Chapter 5 – Dose Modeling RAI Responses

Attachment 1

Sensitivity Chart of Uniform CSM DCGL vs. Increasing CZ Thickness

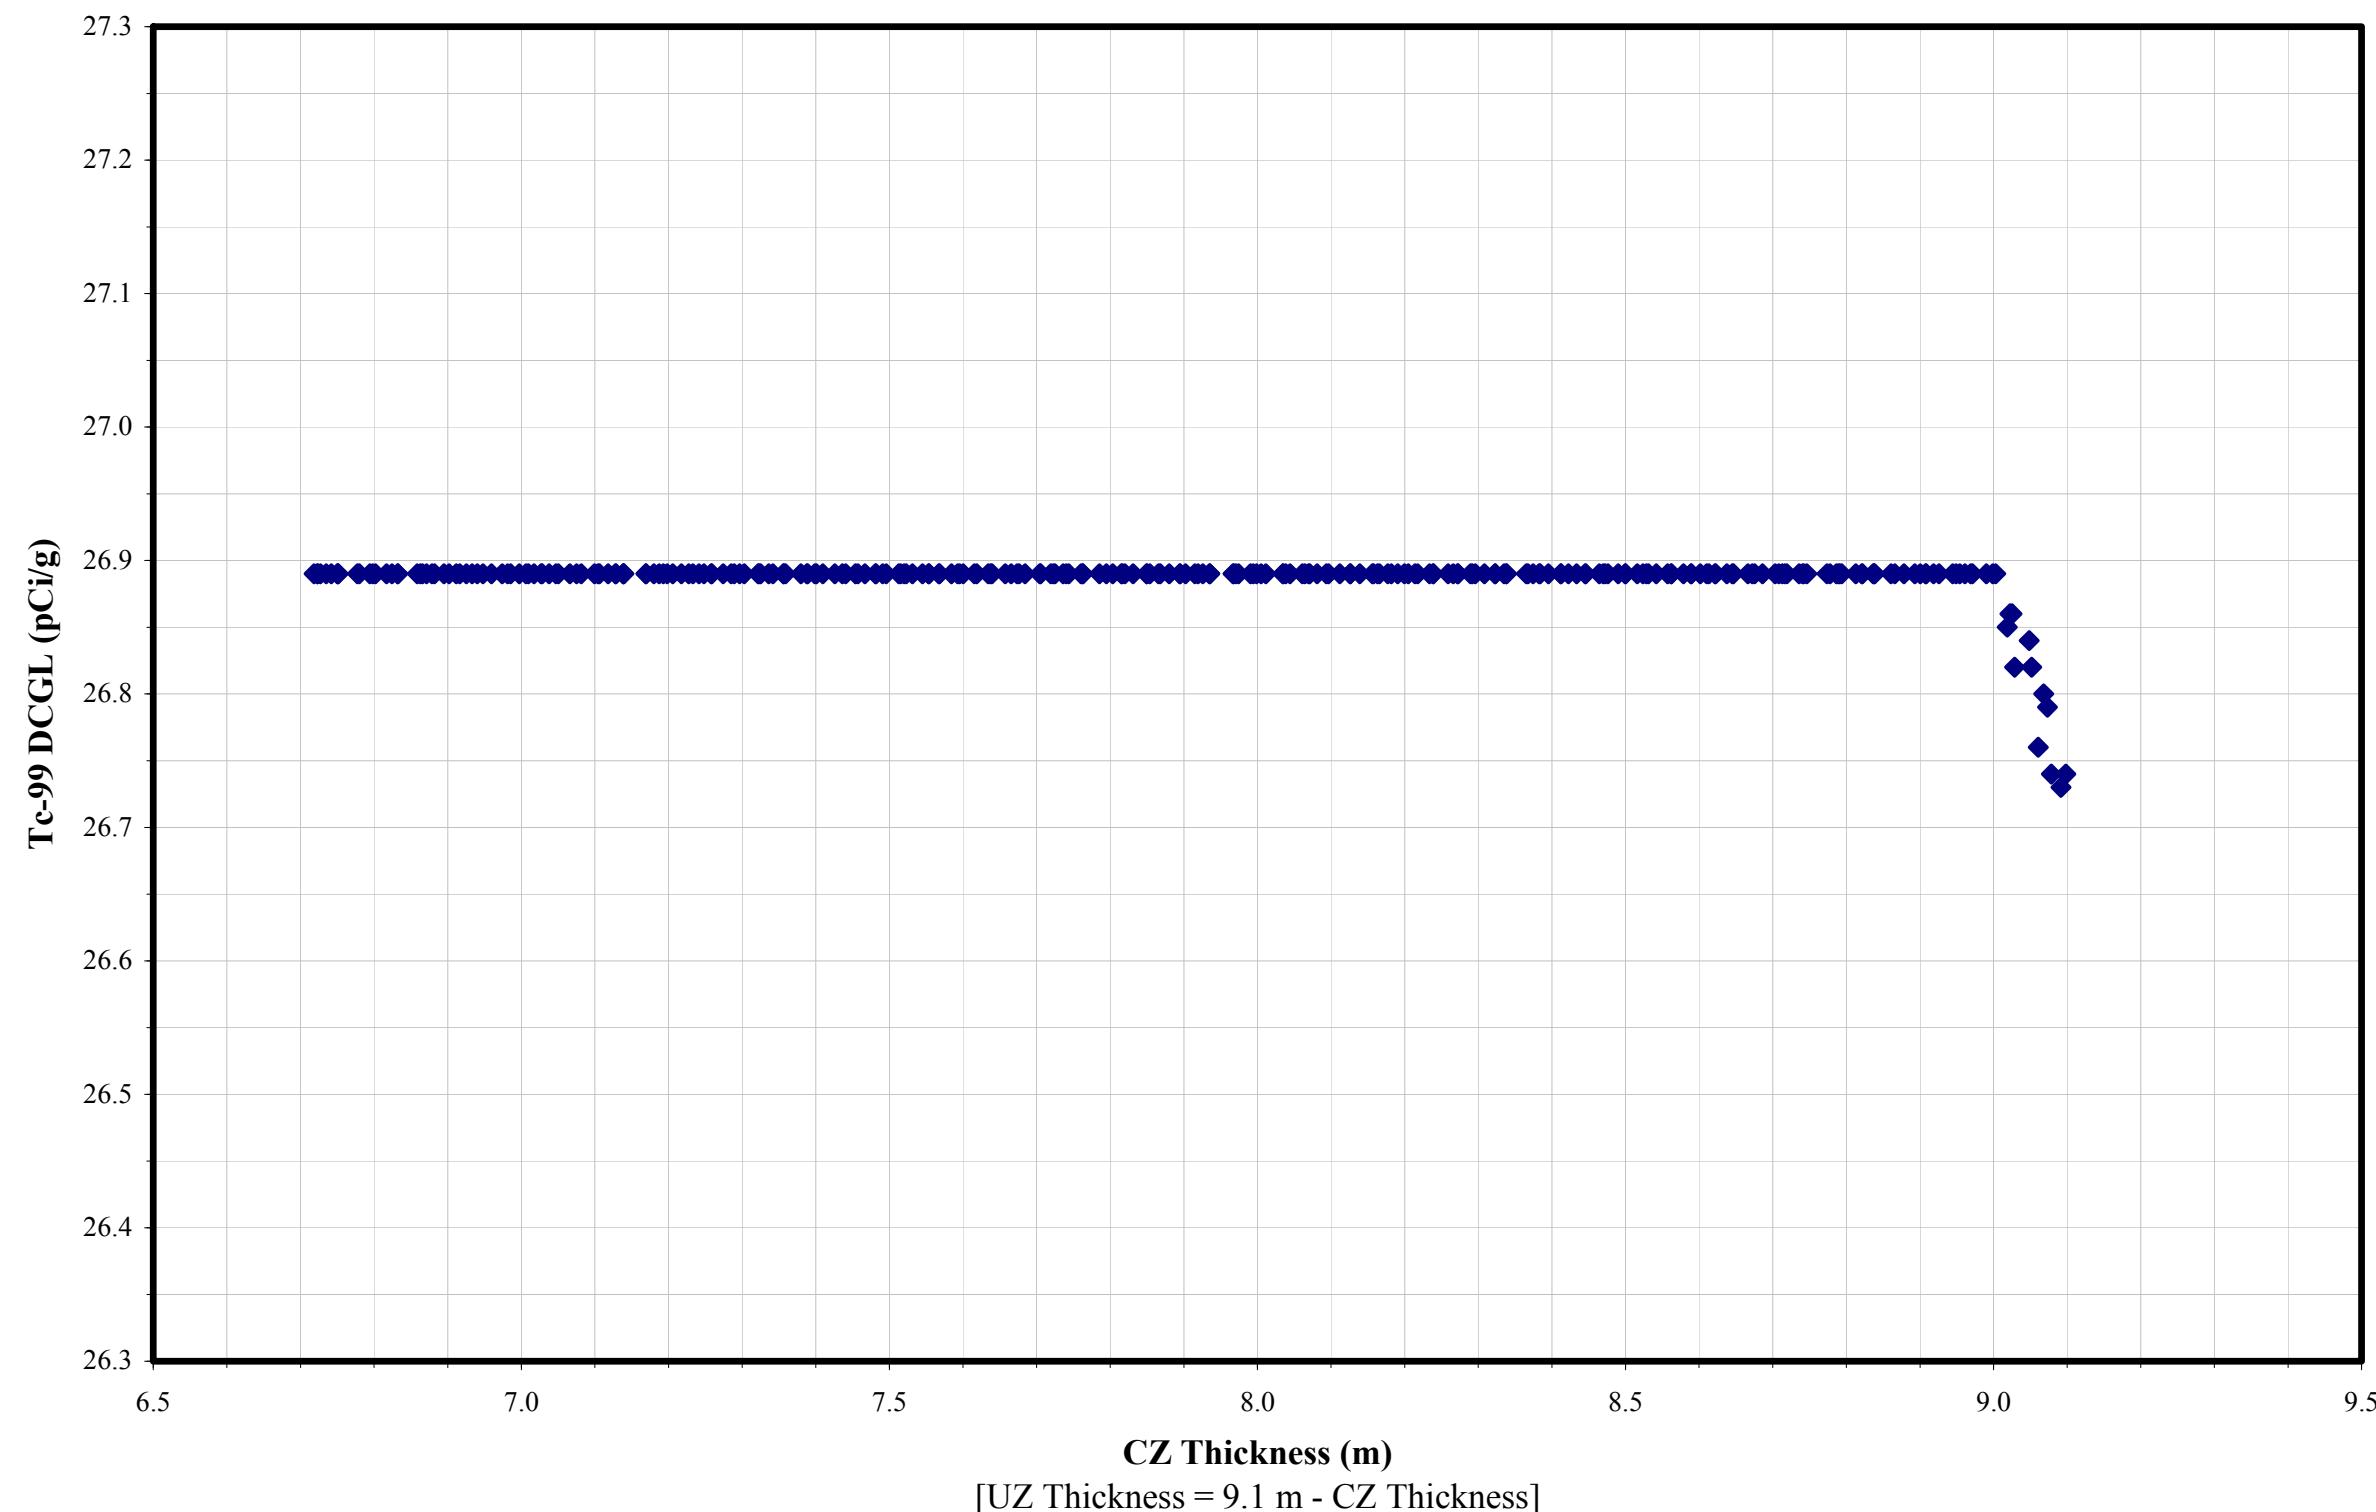
3	Westinghouse showed a sensitivity analysis for the Deep DCGLs but did not discuss how the Uniform DCGLs might be impacted by a similar sensitivity analysis.	Perform a sensitivity analysis showing how the <i>Uniform</i> Tc-99 DGCLs change with variation in the contaminated zone thickness. Send an updated Figure 5-5.	Westinghouse will perform the requested analysis.	<p>1. Westinghouse has performed a sensitivity analysis showing how the <i>Uniform</i> Tc-99 DGCL is affected with variation in the contaminated zone thickness. For the sensitivity analysis, depth of the contaminated zone was varied from 6.7 meters to 9.1 meters while adjusting the size of the unsaturated zone so that the sum of the two remained equal to 9.1 meters. The analysis shows that the model is insensitive to the contaminated zone thickness, as shown in Attachment 1.</p> <p>2. Figure 5-5 has been revised and is provided as Attachment 2.</p>

Uniform CSM Tc-99 Concentration Profile

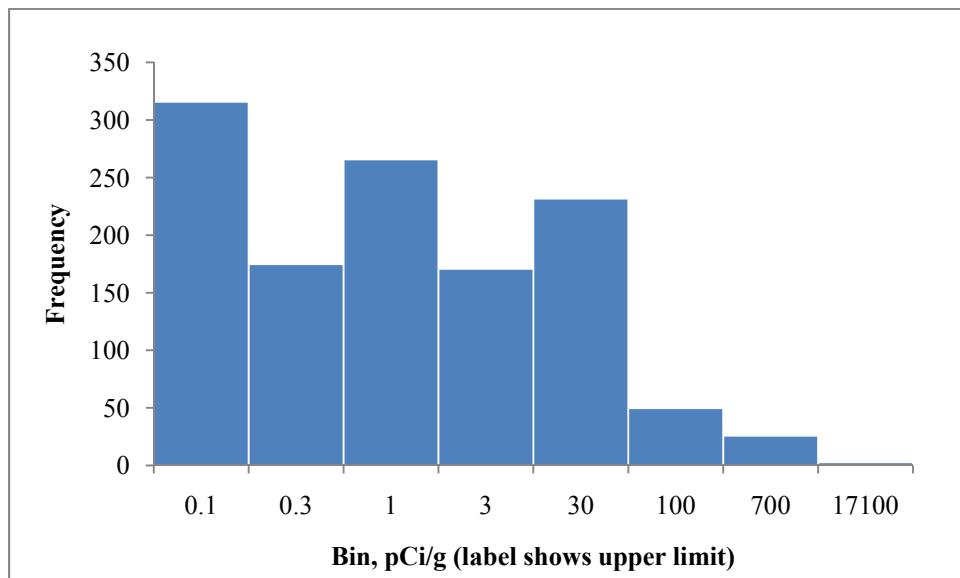
RAI No.	Issues	Path Forward	3/4/11 Discussion Points	Proposed Resolution	NRC Concurrence
6	Conservatism of assumed ratios of radionuclide concentrations in sensitivity analysis is not adequately justified. Some areas of the site have a higher ratio of Tc, than assumed in the sensitivity analyses (i.e., 20%) and the behavior of this radionuclide can be significantly different than other radionuclides.	Perform a sensitivity analysis assuming 100% Tc-99 to see what parameters are sensitive. If additional parameters are found to be sensitive when there is only Tc-99 present, treat these as sensitive parameters in all CSMs.	Westinghouse will perform the requested analysis.	<p>1. Westinghouse performed a sensitivity analysis assuming 100% of the activity was attributed to Tc-99 to determine sensitive parameters. The analysis showed that in addition to the parameters noted as sensitive in Table 5-5 of the Hematite Decommissioning Plan (HDP), the Milk Transfer Factor was a sensitive parameter for only the Uniform CSM. The effect on the DCGL (when recalculated using the 75th percentile of the distribution from NUREG-6697) was relatively minor, and resulted in a maximum reduction of approximately 2%. Attachment 5 provides the sensitivity analysis results and a comparison of DCGLs.</p> <p>As a further refinement to this evaluation, the sensitivity analysis for the Uniform CSM was repeated, using a distribution representative of actual site conditions for the Tc-99 concentration and the average concentration values for all other radionuclides. The radionuclides used in the analysis are shown in Attachment 6. The analysis indicated that the Milk Transfer Factor was not a sensitive parameter.</p> <p>In consideration that the sensitivity for milk transfer factor had only minor impact for the 100% Tc-99 case, and was not identified as a sensitive parameter in the second assessment that was based on actual site conditions, Westinghouse will continue to treat this factor as an insensitive parameter (consistent with the sensitivity analysis presented in the DP).</p>

Radionuclide	Concentration
Am-241	7.13E-03
Np-237	2.03E-02
Pu-239/240	1.63E-03
U-234	4.19E+02
U-235	5.75E+00
U-238	1.41E+01
Tc-99	See figure, below
